Office Action Summary

Application No.
09/873,144

Applicant(s)
ERIK K. JURVIS

DETAILED ACTION

FIG 2

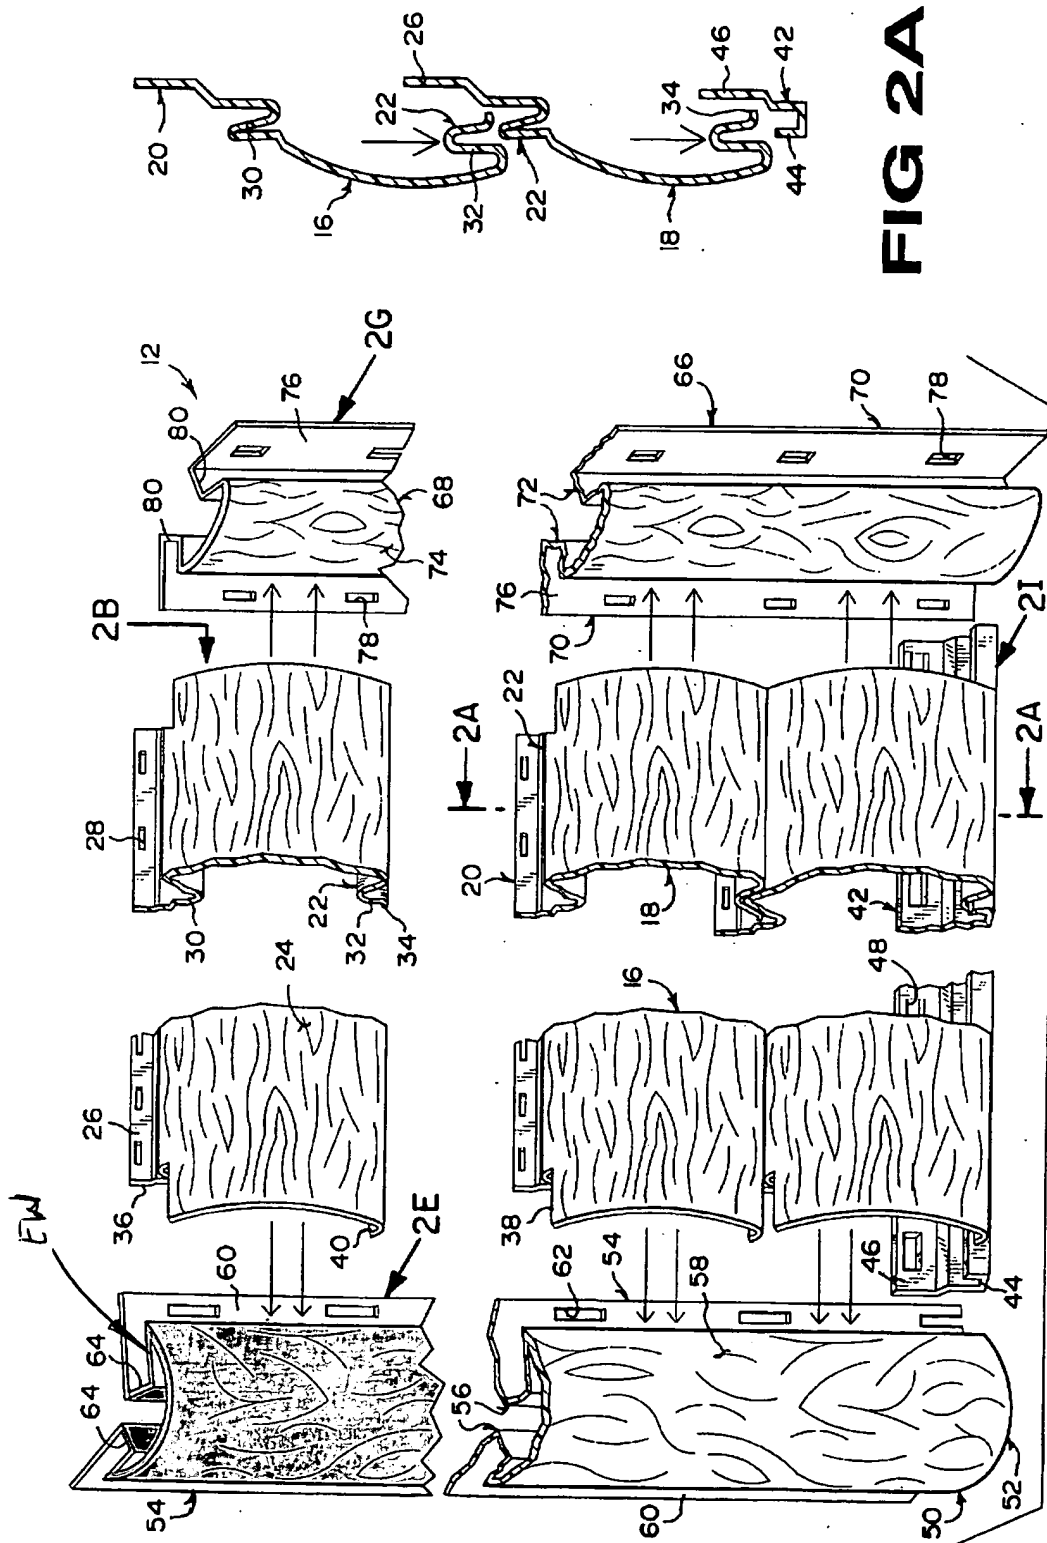
4. Considering objective evidence present in the application indicating obviousness or nonobviousness.
8. Claims 1-4,6,7 and 9-10 are rejected under 35 U.S.C. 102(b) as anticipated by or, in the alternative, under 35 U.S.C. 103(a) as obvious over US Patent #5,694,728 to HEATH, Jr. et al. In claims 1 and 7, the applicant is reminded that “substantially” clearly implies that something less than the exact amount can be required. HEATH, Jr. et al. discloses the use of a component (50) for receiving a plurality of extending siding strips (16) wherein the component (50) includes an elongate body (52) for abutting against a planar wall, column 5, lines 2-5, first and second (64) receivers “substantially” 180 degrees in opposite directions, see figure 2, each for receiving a portion a portion of the horizontally extending siding strips (16), and an outwardly bowed portion (colored red). Each receiver (64) is “substantially” U-shaped and includes a first wall (colored green) for at least partially covering the end of the siding strip (16), an end wall (EW) connected to the first wall (colored green), and a fastener receiving portion (60) for abutting the wall of the building (14), column 5, lines 2-5, see the marked attachment. Although the first and second receivers of the component of HEATH, Jr. et al. do not extend at exactly or precisely 180 degrees, they do extend “substantially” at 180 degrees in opposing directions. Hence, it would have been obvious to one having ordinary skill in the art at the time the invention was made that the device of HEATH, Jr. et al. include receivers that extend “substantially” at 180 degrees in opposing directions. Regarding claim 2, as stated above, the system of HEATH, Jr. et al. includes integral fastener receiving portions (60). In reference to claims 3 and 4, the outwardly bowed portion (colored red) of HEATH, Jr. et al. is integrally connected to a portion of each

receiver (64) and includes indicia (58), column 5, lines 11-13, that stimulates the appearance of the system. Regarding claim 6, as stated earlier, each receiver includes an end wall (EW), see the marked attachment. In reference to claim 7, the end walls (EW) are “substantially” parallel and are spaced apart. Regarding claim 9, the first wall (colored green) of each receiver (64) is indirectly integrally connected to an end of the outwardly bowed portion (colored red) through the end wall (EW); wherein, the outwardly bowed portion (colored red) simulates the appearance of a log, column 5, lines 11-13. In reference to claim 10, the fastener receiving portion (60) is elongated relative to the first wall (colored green) of the corresponding receiver (64).

FIG 1

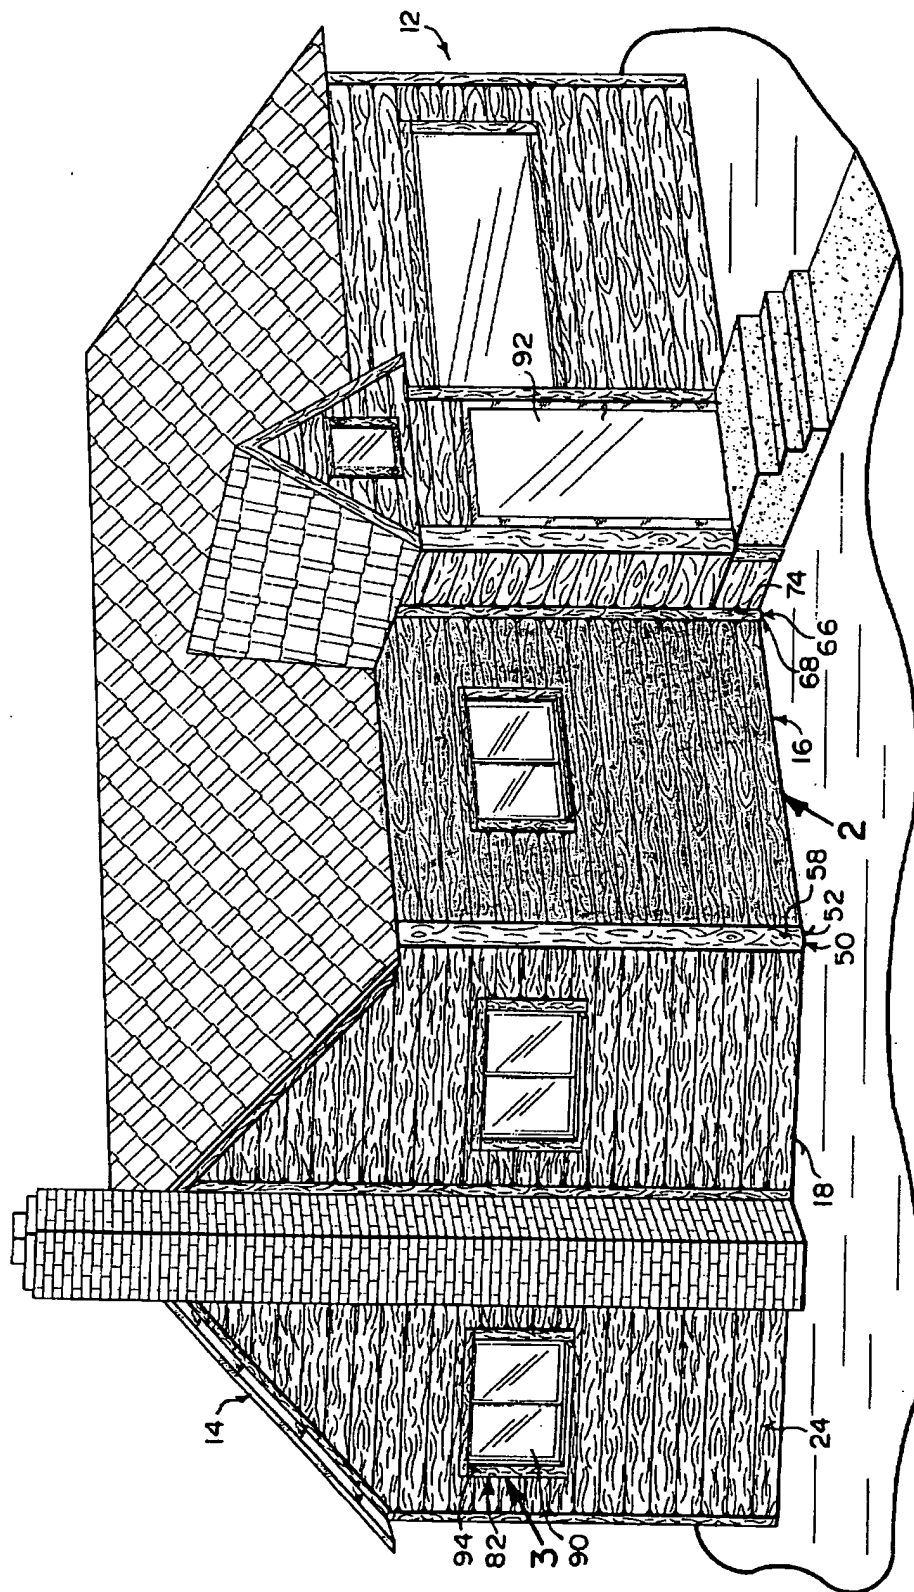
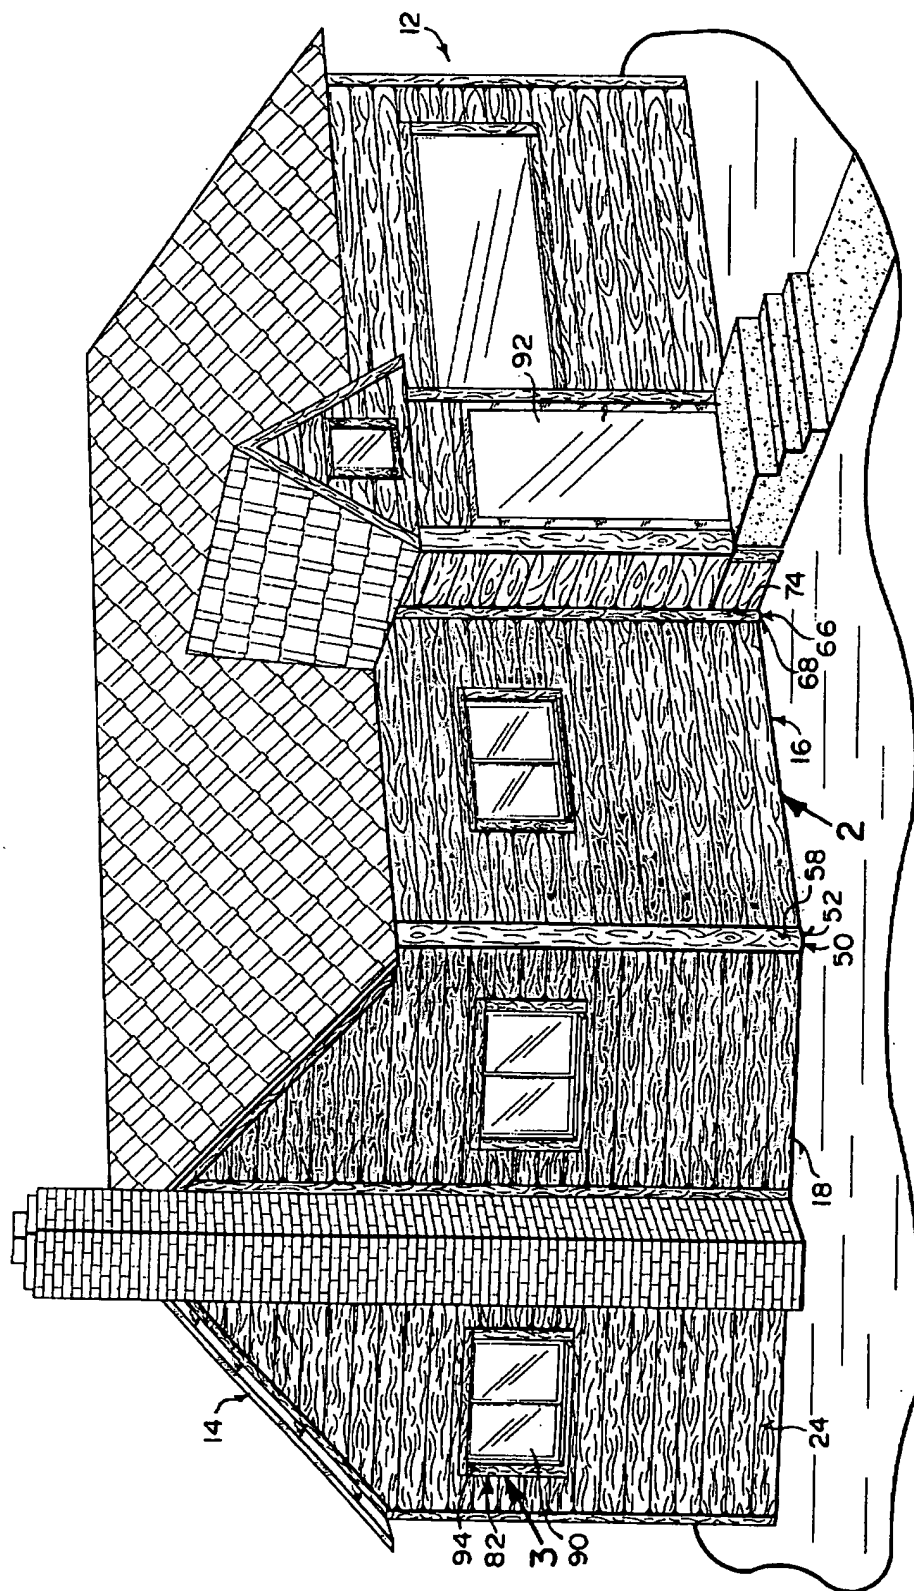
9. Claims 11-13 and 15-16 are rejected under 35 U.S.C. 102(b) as anticipated by or, in the alternative, under 35 U.S.C. 103(a) as obvious over US Patent #5,694,728 to HEATH, Jr. et al. In claims 11-13, the applicant is reminded that “substantially” clearly implies that something less than the exact amount can be required. HEATH, Jr. et al. discloses the use of a vertically extending component (50) for receiving at least a first and at least a second “substantially” horizontally extending siding strips (16) wherein the component (50) includes an elongate body (52) for abutting against a planar wall, column 5, lines 2-5, first and second (64) receivers “substantially” 180 degrees in opposite directions, see figure 2, each for receiving a portion a portion of the horizontally extending siding strips (16), and an outwardly bowed portion (colored red). Each receiver (64) is “substantially” U-shaped and includes a first wall (colored green) for at least partially covering the end of the siding strip (16), an end wall (EW) connected to the first wall (colored green), and a fastener receiving portion (60) for abutting the wall of the building (14), column 5, lines 2-5, see the marked attachment. Although the first and second receivers of

the component of HEATH, Jr. et al. do not extend at exactly or precisely 180 degrees, they do extend “substantially” at 180 degrees in opposing directions. Hence, it would have been obvious to one having ordinary skill in the art at the time the invention was made that the device of HEATH, Jr. et al. include receivers that extend “substantially” at 180 degrees in opposing directions. Regarding claim 12, the first and second siding strips (16) are positioned “substantially” in the same vertical plane (colored blue), see the marked attachment. In reference to claim 13, the first and second siding strips (16) are positioned “substantially” in the same horizontal plane (colored yellow), see the marked attachment. Regarding claim 15, the system of HEATH, Jr. et al. further includes at least one fastener (unlabeled), column 5, line 2-4, for fastening each fastener receiving portion (60) to the wall of a building (14). Regarding claim 16, the first wall (colored green) of each receiver (64) is indirectly integrally connected to and end of the outwardly bowed portion (colored red) through the end wall (EW); wherein, the outwardly bowed portion (colored red) simulates the appearance of a log, column 5, lines 11-13.

10. Claim 17 is rejected under 35 U.S.C. 102(b) as anticipated by or, in the alternative, under 35 U.S.C. 103(a) as obvious over US Patent #5,694,728 to HEATH, Jr. et al. The applicant is reminded that “substantially” clearly implies that something less than the exact amount can be required. The structure of HEATH, Jr. et al. inherently discloses the method for installing a plurality of siding members (16) including the steps of providing an elongated component (50) having an outwardly bowed body (colored red), see the marked attachment, first and second receivers (64) extending at “substantially” 180 degrees in opposing directions, and a first wall (colored green), see the marked attachment; vertically orienting the elongated component (50);

inserting the first end of the plurality of siding members (16) into one of a first or second receiver (64); inserting a second end of the plurality of siding members (16) into one of a first or second receiver (64); and affixing the siding members (16) to the wall (unlabeled) of a building (14), column 5, lines 2-5; wherein each receiver (64) includes a fastener receiving section (60) and the steps further include placing at least one fastener through the fastener receiving section (60), column 5, lines 11-13.
